CITY OF DUNDEE
PLANNING COMMISSION AGENDA
City Council Meeting Chambers
620 SW 5th Street
Dundee, OR 97115
P.O. Box 220

- S 16-20, Alder Terrace Subdivision

The request is to divide two existing parcels into 12 lots for a subdivision known as Alder Hill subdivision. The proposal is a relatively straightforward subdivision that meets all of the lot dimensional and access requirements in the Dundee Development Code. The proposed subdivision will improve their respective street frontages on Alder Street and 7th Street with sidewalks. The biggest issue facing the proposed subdivision will be to provide an alternate method for stormwater than what is proposed, due to the lack of existing facilities on the adjacent property that were not installed at the time of development. There are several options for the alternate stormwater plan, and those will be reviewed and approved by the City Engineer per the conditions of approval. The applicant did provide an erosion control plan that will be followed during construction to mitigate impacts to neighboring properties.

1 SW 7TH ST SECTION
 C2.1 SCALE: N.T.S.

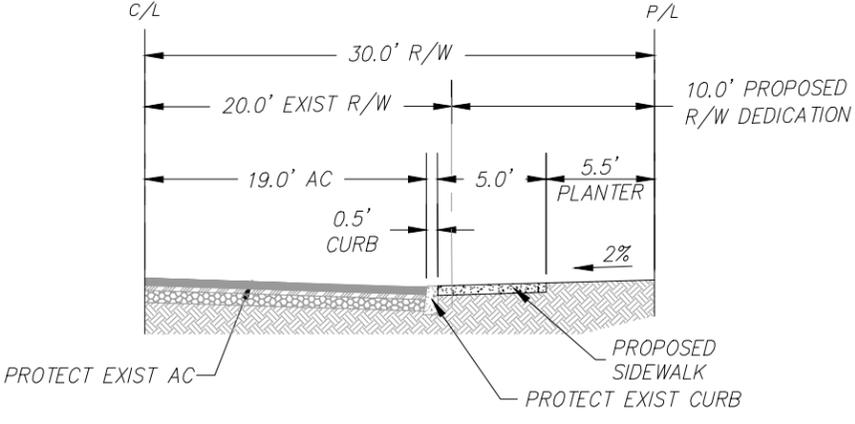
- **7th Street:**
 - Provide for a setback sidewalk per the TSP. Since the adjoining sidewalk to the east is curb tight, consider transitioning to the separated sidewalk at the first driveway using a separated sidewalk driveway.

- Due to the number of proposed curb cuts for driveways and utilities, replacement of all or portions of the curb will likely be necessary.
 - Provide two (2) ADA sidewalk ramps to receive pedestrians from the ramps at Graystone Drive.

2 ALDER ST SECTION
 C2.1 SCALE: N.T.S.

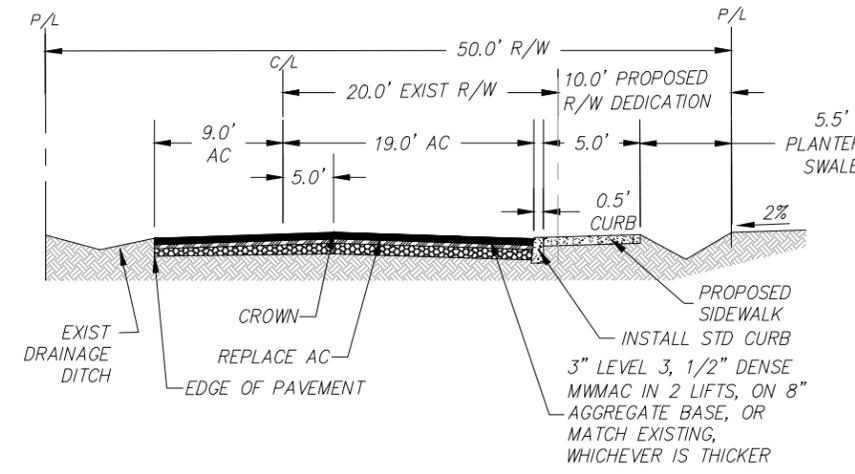
1. **Street Improvements:** Provide engineered plans for Engineering Department approval showing the items listed below.
 - **Alder Street:**
 - The street section should accommodate the potential future improvement to the full City of Dundee Collector configuration per the TSP which requires a 36' pavement width. The proposed section should be revised to center the crown within a future 36' wide section (18' from proposed curb) and 30 feet from the proposed right of way along the development after the 10 foot dedication.

- The proposed 28 feet wide section is acceptable for the required three quarter street improvement with the full pavement width reconstructed.
 - Either provide a 6-foot curbside sidewalk and a setback planter strip/swale or a 5-foot setback sidewalk and a curbside planter strip/swale.

3 PRIVATE ACCESS EASEMENT
 C2.1 SCALE: N.T.S.

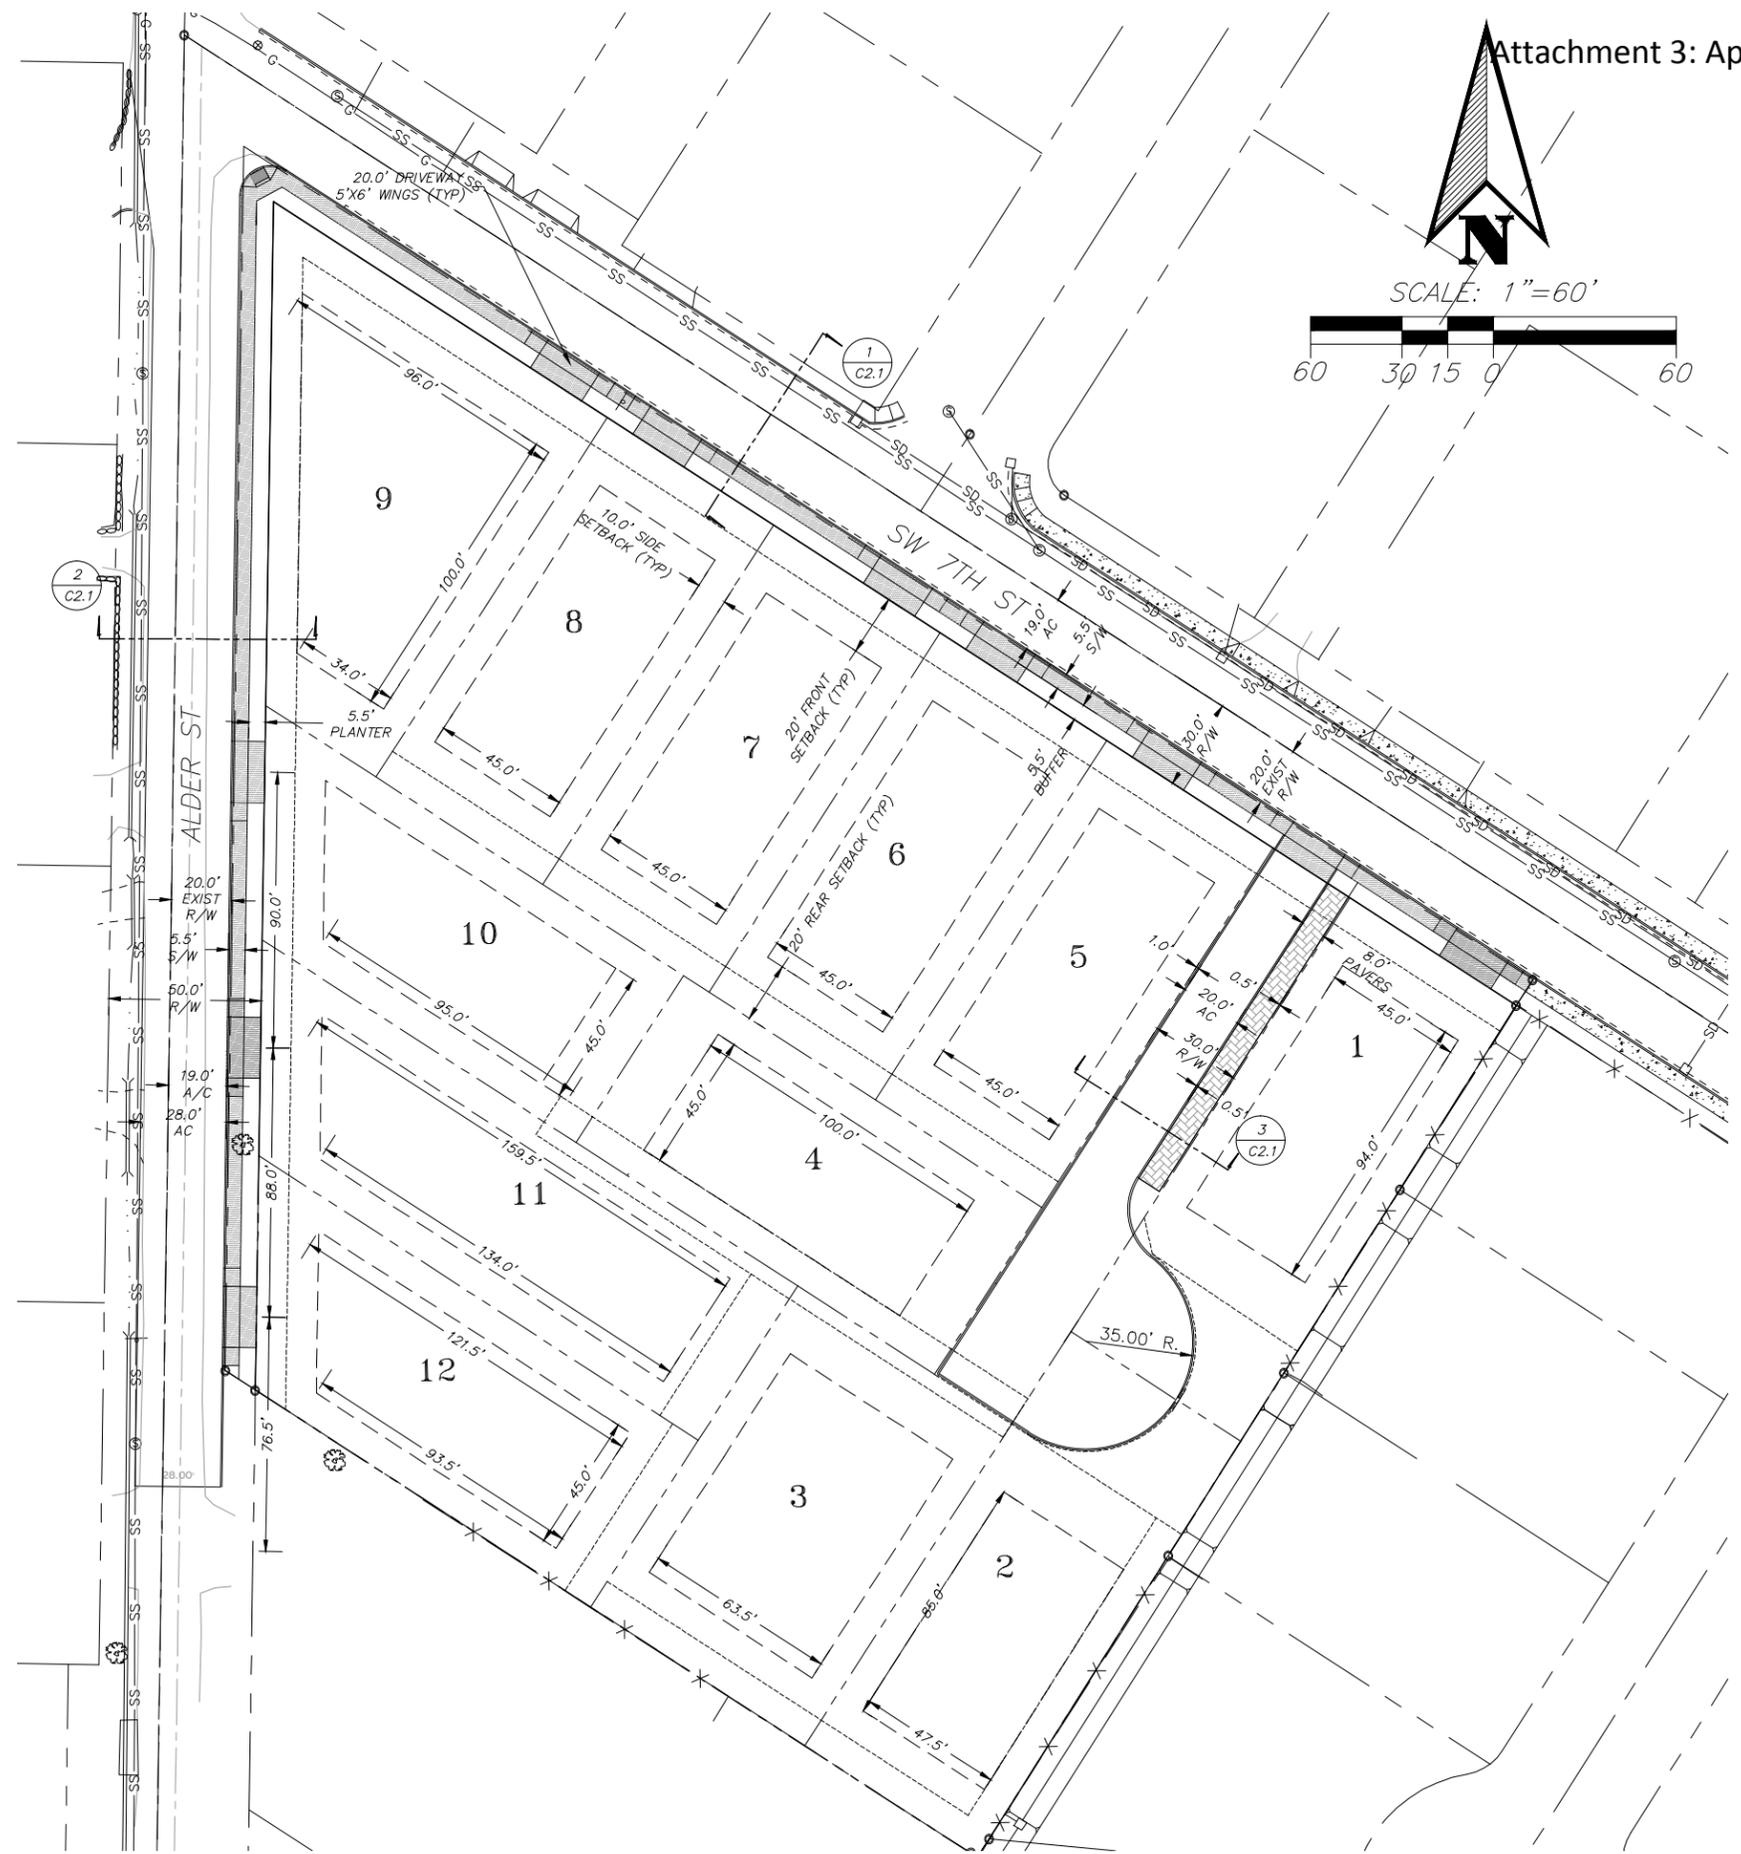
- **Visitor Parking:** Consider relocating the curbing from the proposed 8-foot wide walkway within the access easement and designating that area as visitor parking instead of using it as a walkway. This would provide additional off-street visitor parking for lots 2, 3, and 4.

99 STORM DRAINAGE PLAN
 SCALE: 1" = 60'

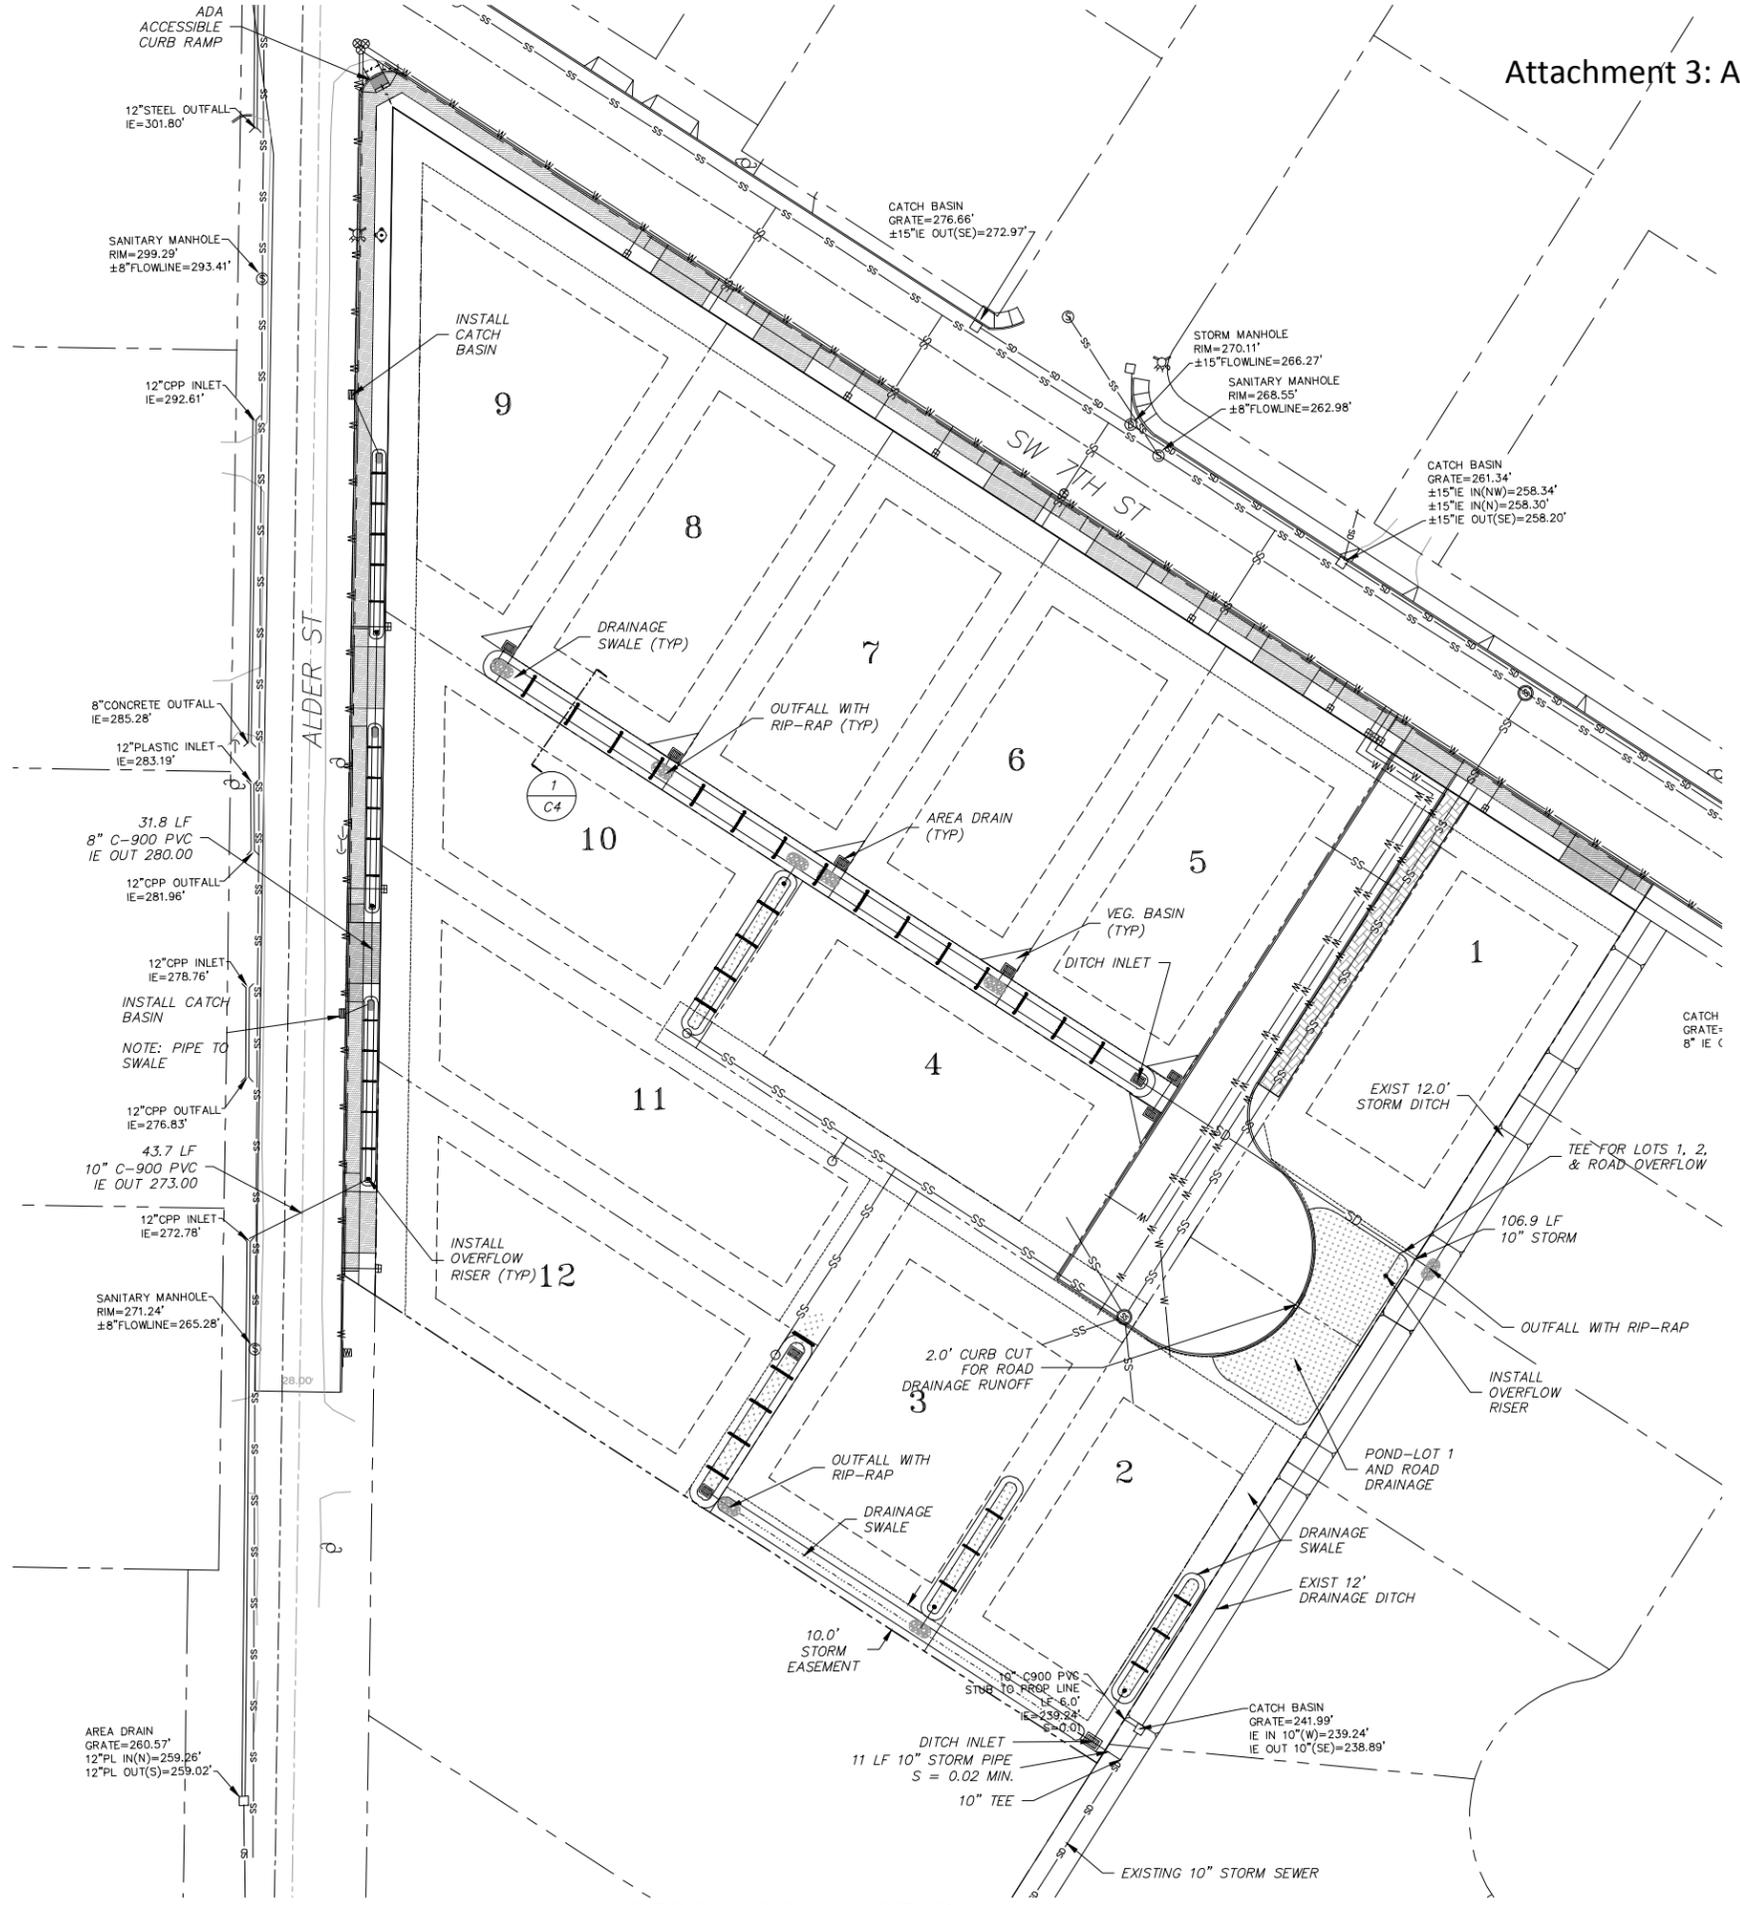
- **Stormwater:**
 - The drainage ditch on the adjacent property shown on the preliminary plat was never built with the Highland Place subdivision, does not currently exist, and increasing surface flows to this off-site easement will not be permitted. Provide an alternate method for City Engineer review and approval to get the private stormwater to the public system.

- A method for long-term maintenance of the private stormwater facilities, such as recorded maintenance agreements, must be provided that is acceptable to the City. Consider individual stormwater facilities such as flow through planter boxes to serve each lot so that maintenance responsibilities can be clearly defined.

- Provide access for City inspections through easements and maintenance agreements.
 - The stormwater facilities must be permanent facilities that will not be easily filled or modified, and maintenance procedures will need to be defined, approved by the City, and documented in the recorded agreements. The design of the chosen stormwater system will also need to identify and address groundwater levels within the design of the facilities.
